**FORTHWIND LTD, OFFSHORE WIND DEMONSTRATION PROJECT, FIRTH OF
FORTH, OFFSHORE FROM METHIL, FIFE.**

**MARINE SCOTLAND - LICENSING OPERATIONS TEAM
SCOPING OPINION**

**SCOPING OPINION FOR THE PROPOSED SECTION 36 CONSENT AND
ASSOCIATED MARINE LICENCE APPLICATION(S) FOR INSTALLATION OF AN
OFFSHORE WIND DEMONSTRATION PROJECT**

Figure 1: Location of the Development

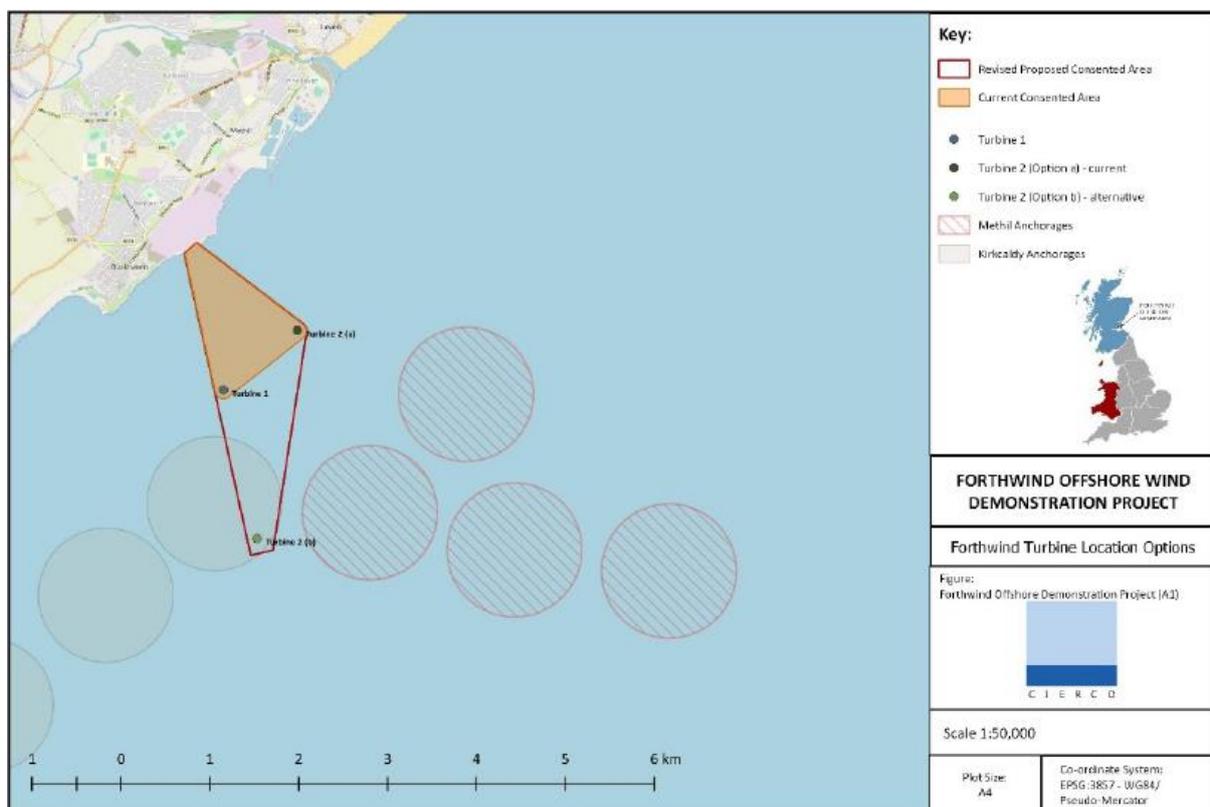
3.1.6 “Option B” is locating one WTG in location ‘turbine 1’ as shown in figure 1 and locating the second WTG further offshore approximately 3.5km from Methil (Turbine 2 (b) as shown in Figure 1).

3.1.8 Forthwind propose deployment of these WTG for no more than 25 years from final commissioning. The cable and the cable landfall point will be within the red line detailed in Figure 1.
